TO:  Marco Foster, MS47354  
THRU:  T. Madden / K. Klingman, NB82-230  
FROM:  P. Fuller / S. Beadle, NB 82-66  
SUBJECT: C8549  
SR99, AWV Replacement North Access Connection  
F.A. Project No: STPF-0099(122)  
**CHANGE ORDER 133**  
**Ductbank Changes EN1, EN3, EN4 & EP5**

**WASHINGTON STATE  
DEPARTMENT OF TRANSPORTATION  
CHANGE ORDER**

CONTRACT NO: 008549 FEDERAL AID NO: STPF-0099(122)  
 CONTRACT TITLE: SR 99, ALASKAN WAY VIADUCT - REPLACEMENT NORTH ACC  
 CHANGE ORDER NO: 133 R1 EN1, EN3, EN4, EP5 DUCTRANK CHGS.

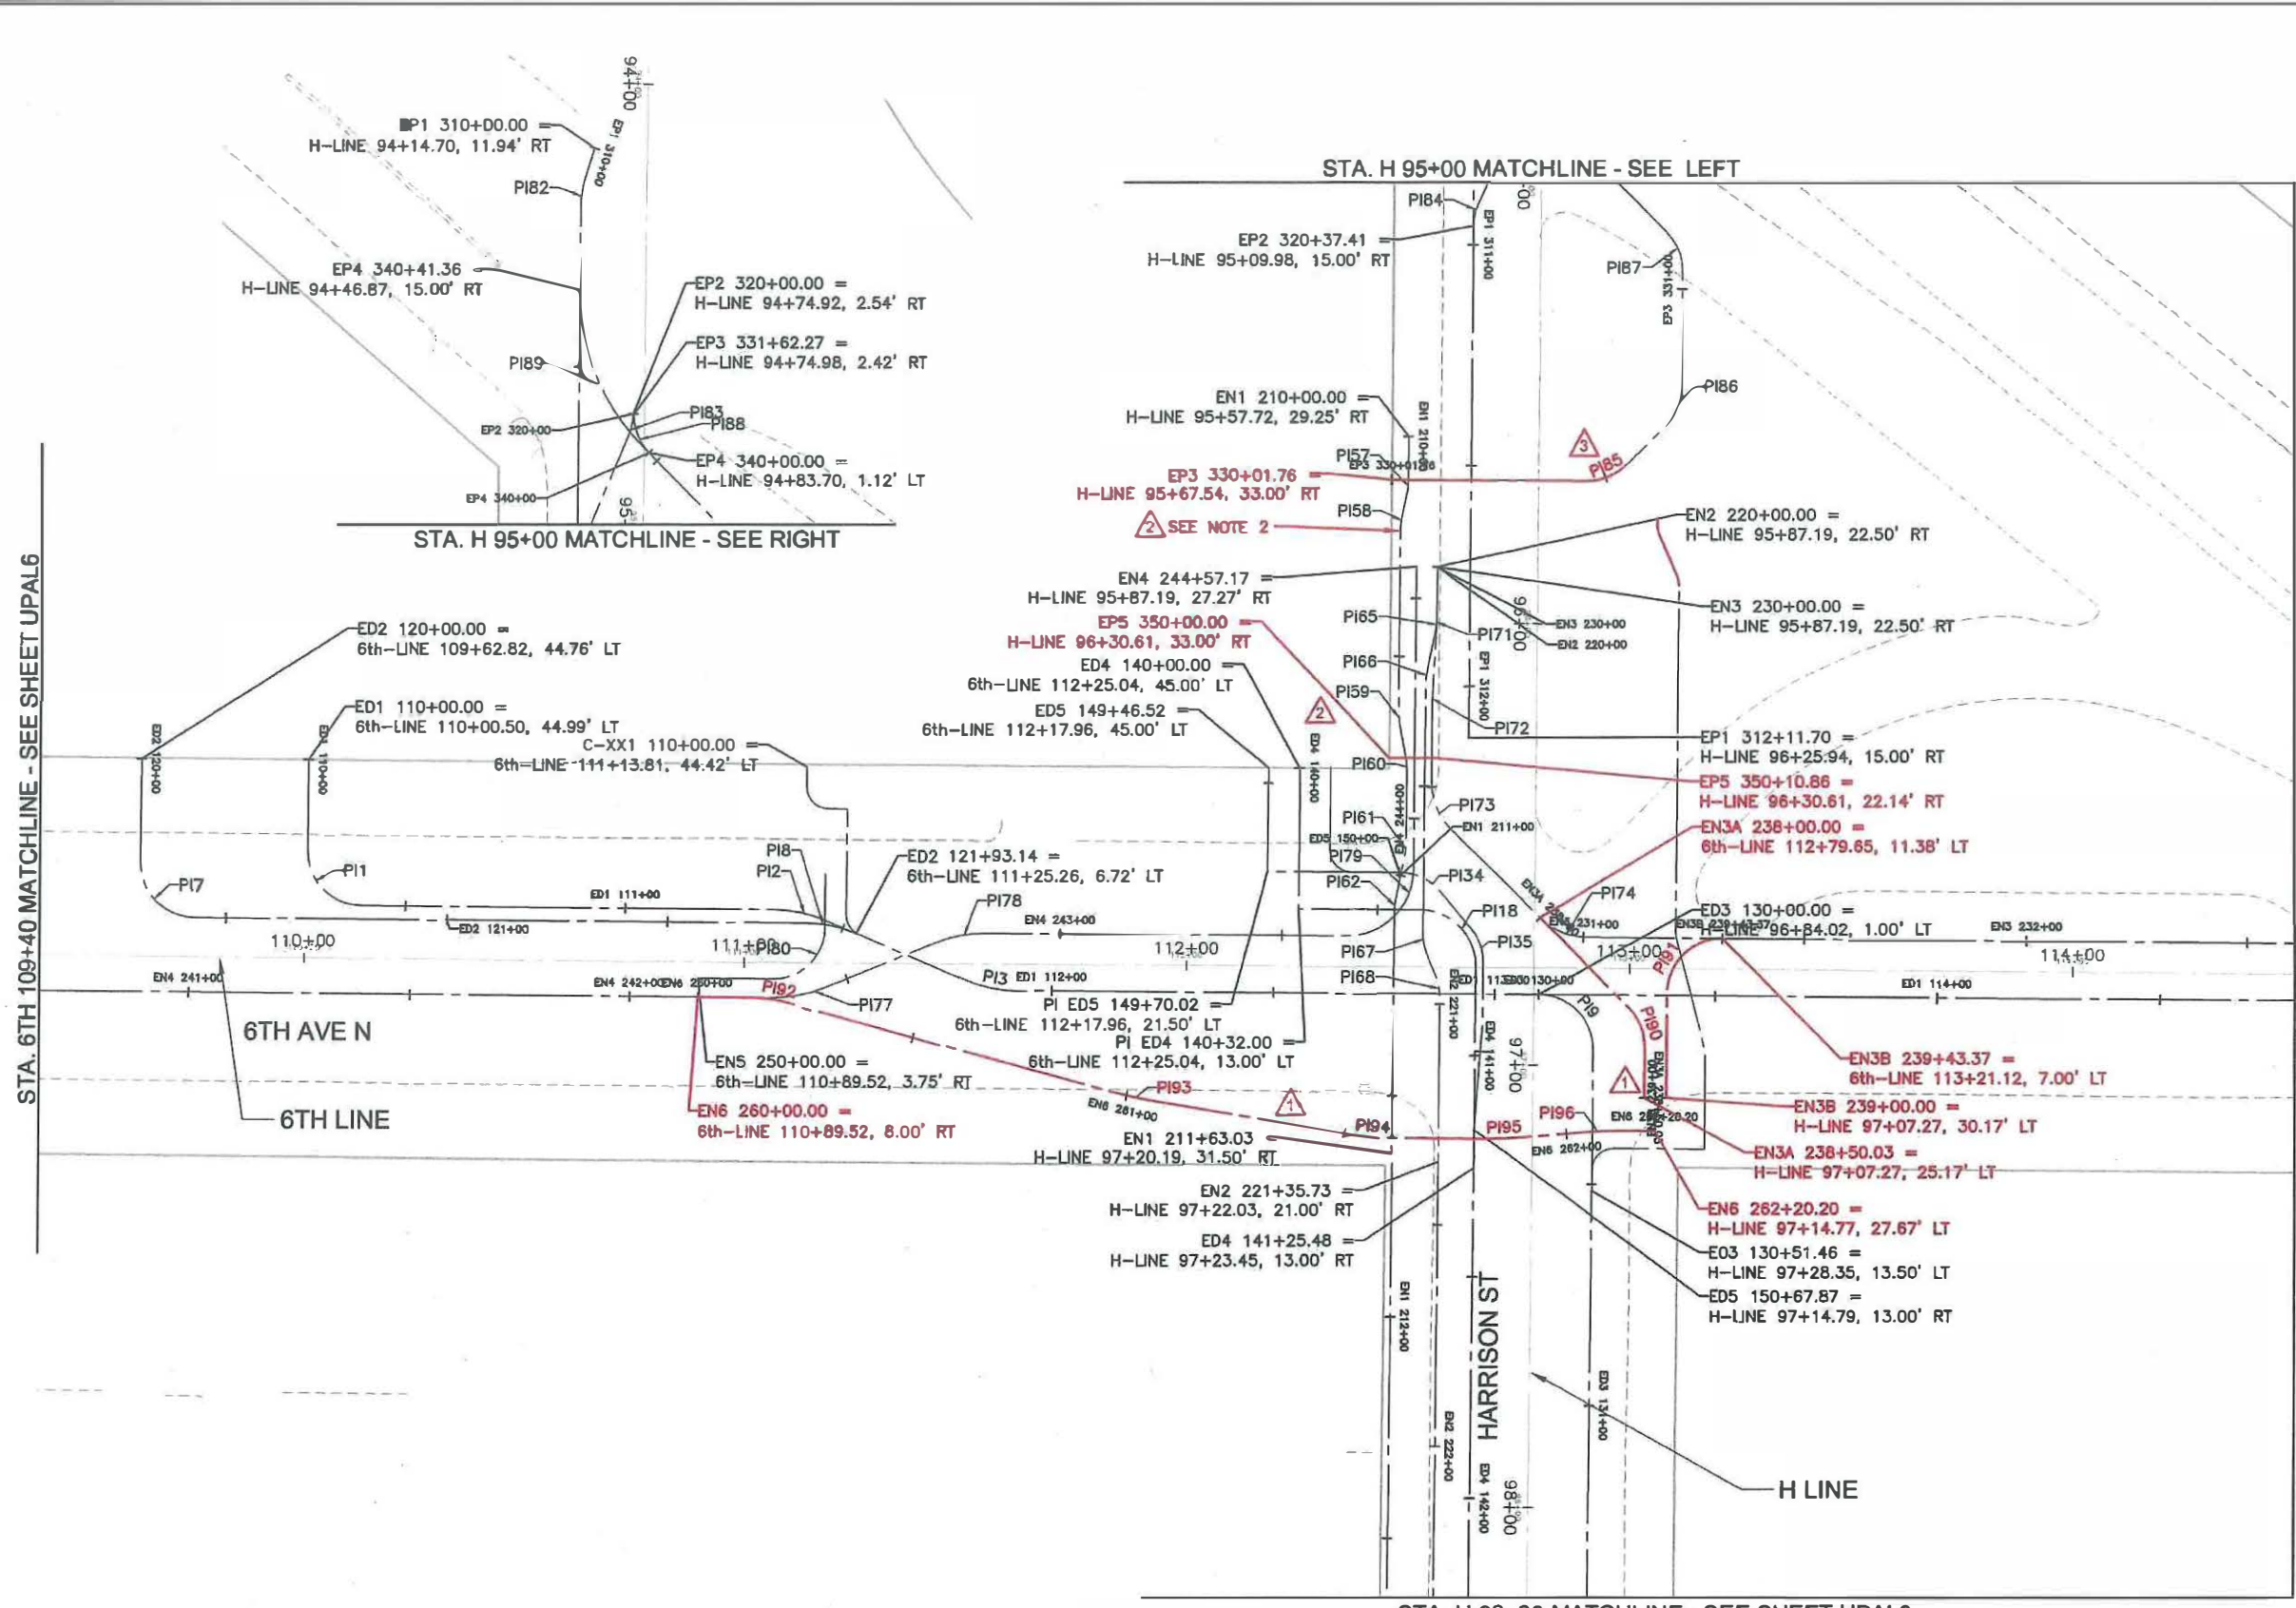
Revises the horizontal and vertical alignment of ductbank EN1 as shown on UPAL1, UP1 and UPR7. Raises EN1 vertical alignment to be above new ductbank EP5 and above EN2 and EN4 as shown on UPD33 and UPD33A. Revises horizontal alignment to run along the Substation Yard retaining wall foundation. This change order compensates the Contractor for the added effort and complexity for working along the SCL Substation retaining wall as shown on UPD33 and UPD33A.

Revises the horizontal and vertical alignments of ductbank EN3 as shown on UPAL1, UP1, UP8, UPR8, UPR9, UPD11 and UPD33.

Adds new ductbank EP5 feeders from Station EP5 350+00.00 to 350+10.86 to the SCL Substation yard as shown on UPAL1, UP1, UPR7-UPR9, UPR10, UPD20, UPD33. New ductbank EP5 shall be positioned in between ductbanks EN1 and EN3 above and ductbanks EN4 and EN2 below.

This change order revises the following plan sheets UPAL1, UP1, UP8,

PLAN REF. NO.  
**UPR9**  
 SHEET  
**227**  
 OF  
**770**  
 SHEETS

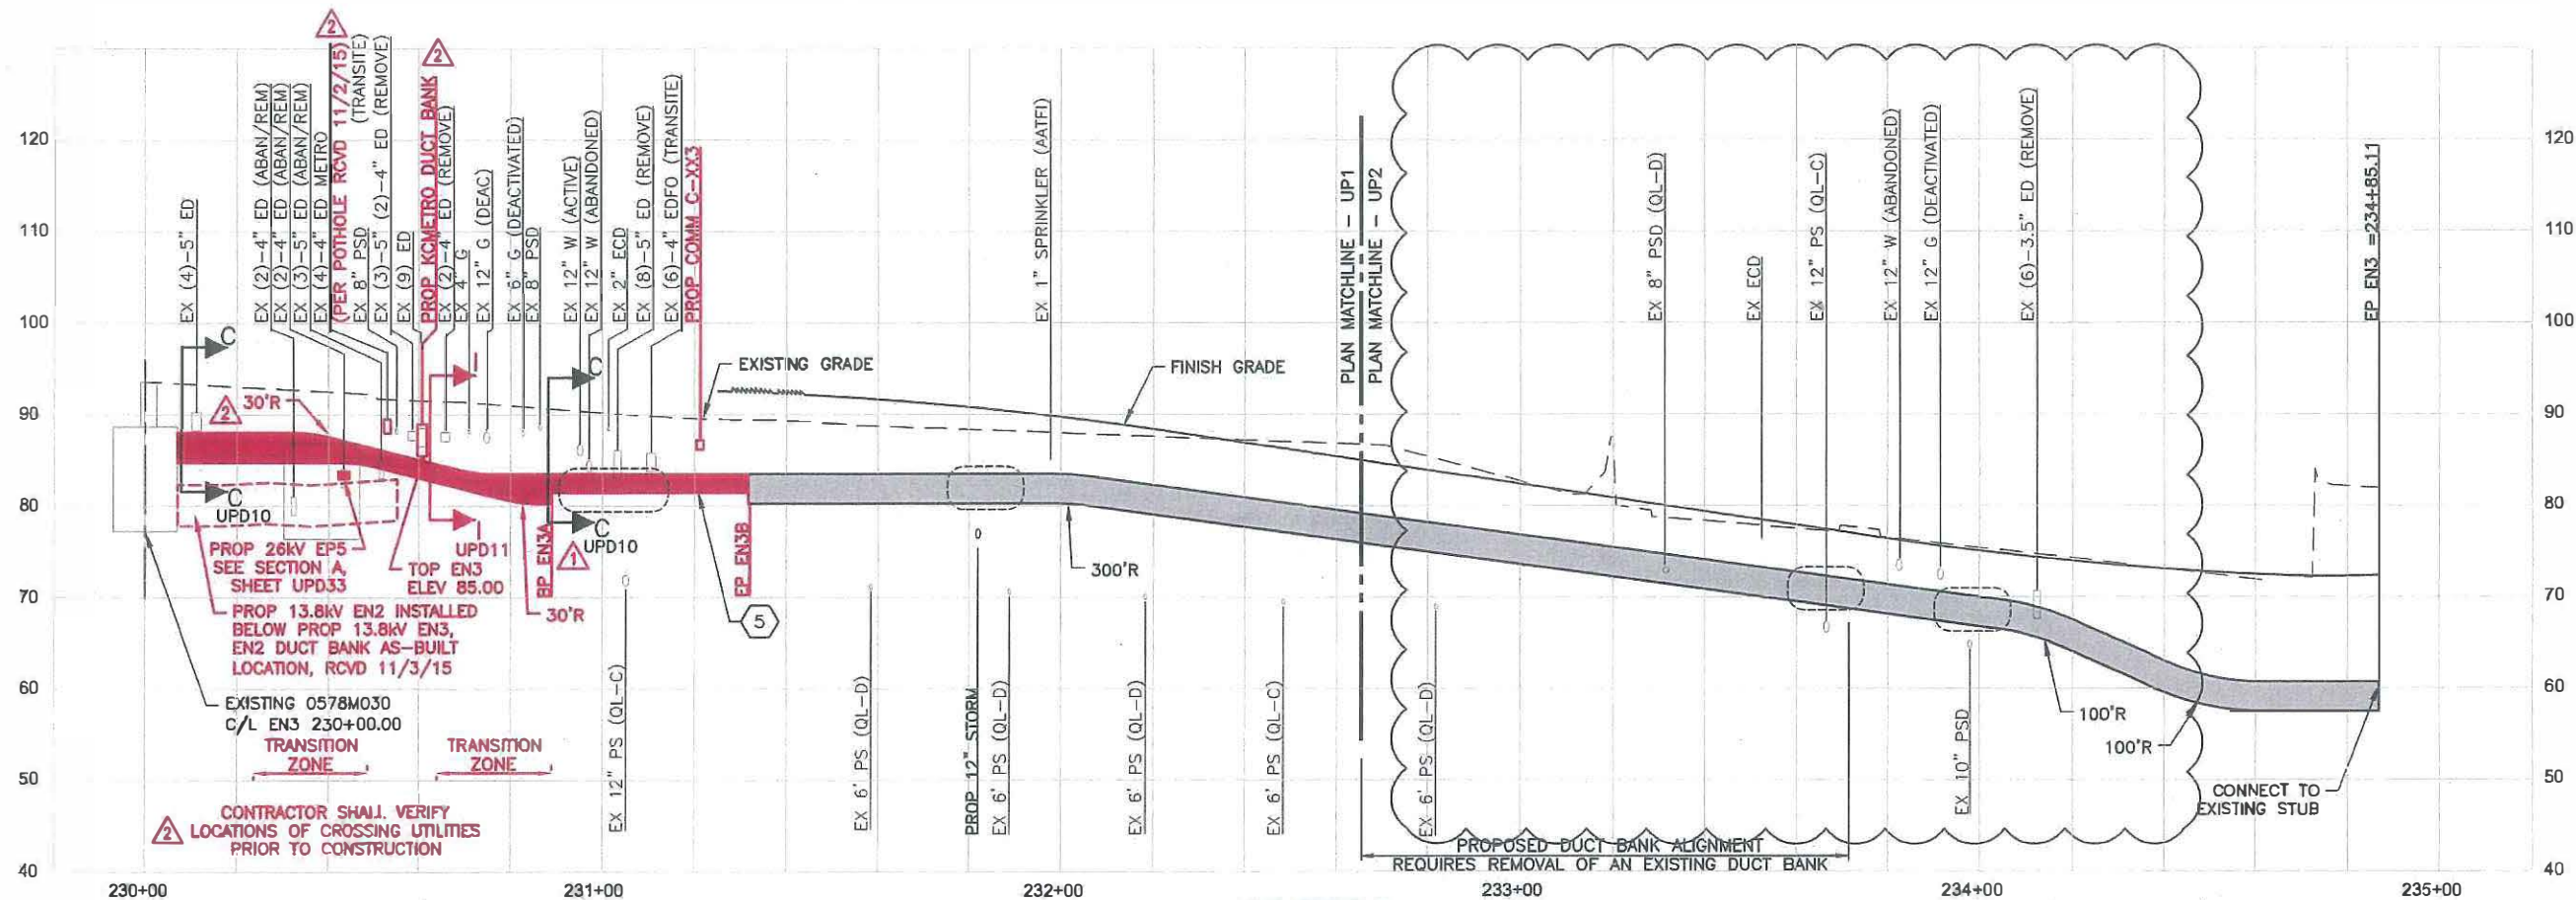
This change order makes ductbank adjustments to avoid future King County ductbank as shown on UPR9.

PLAN REF. NO.  
**UPR10**  
 SHEET  
 228  
 OF  
 770  
 SHEETS

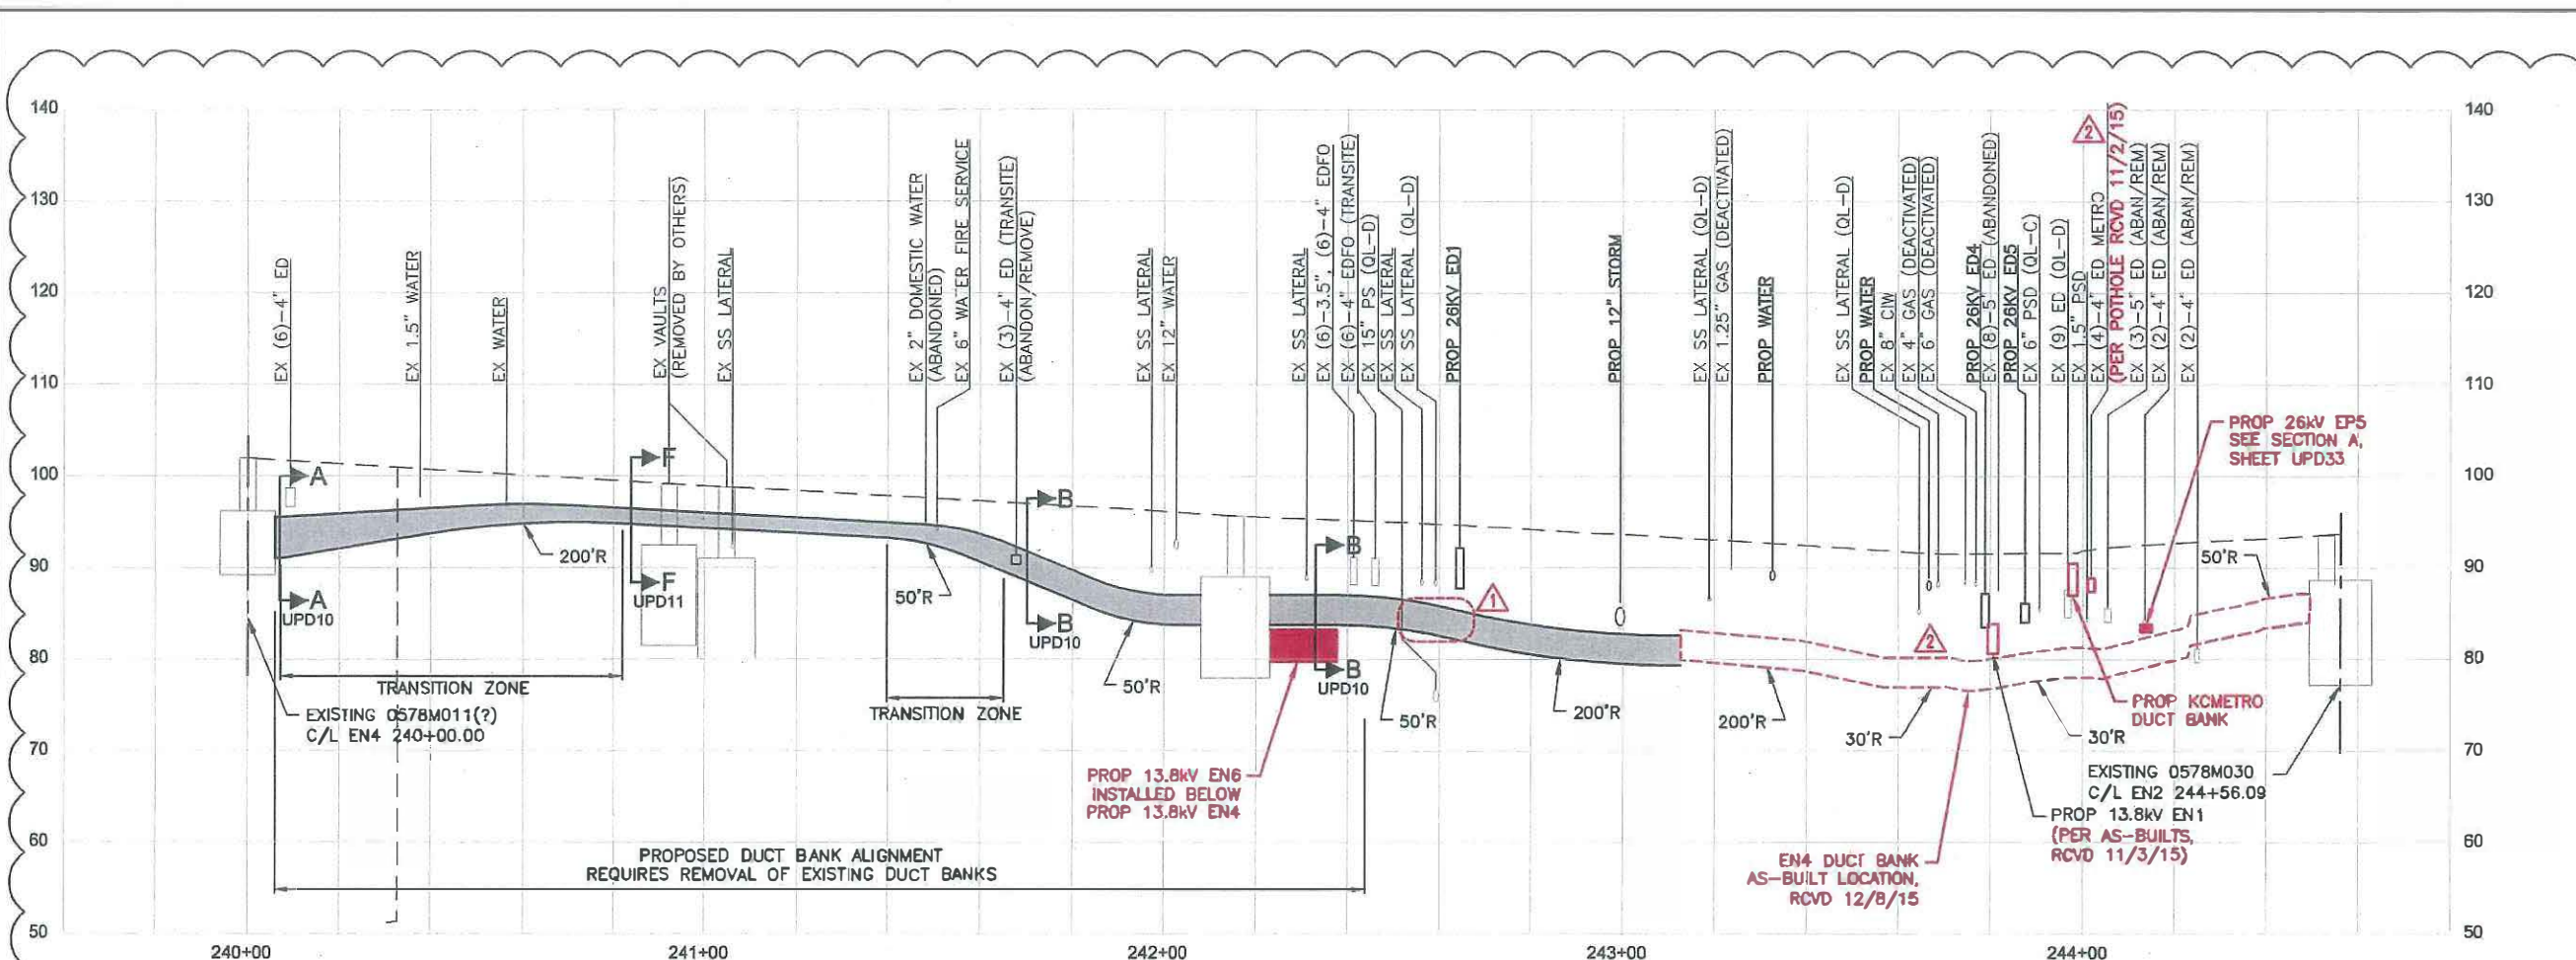
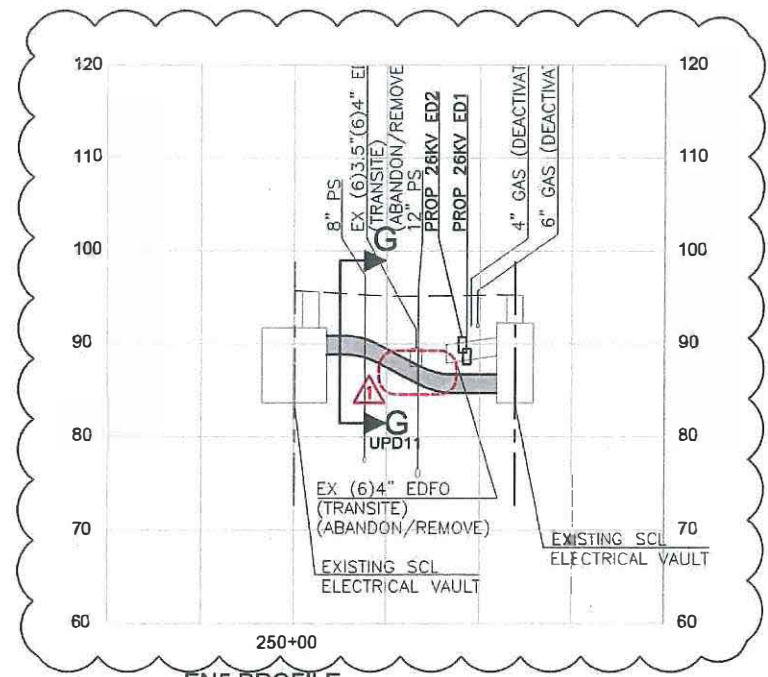
Adds new reinforcement cage to EN4 per SCL Guideline U2-11.2 as shown on UPR10.
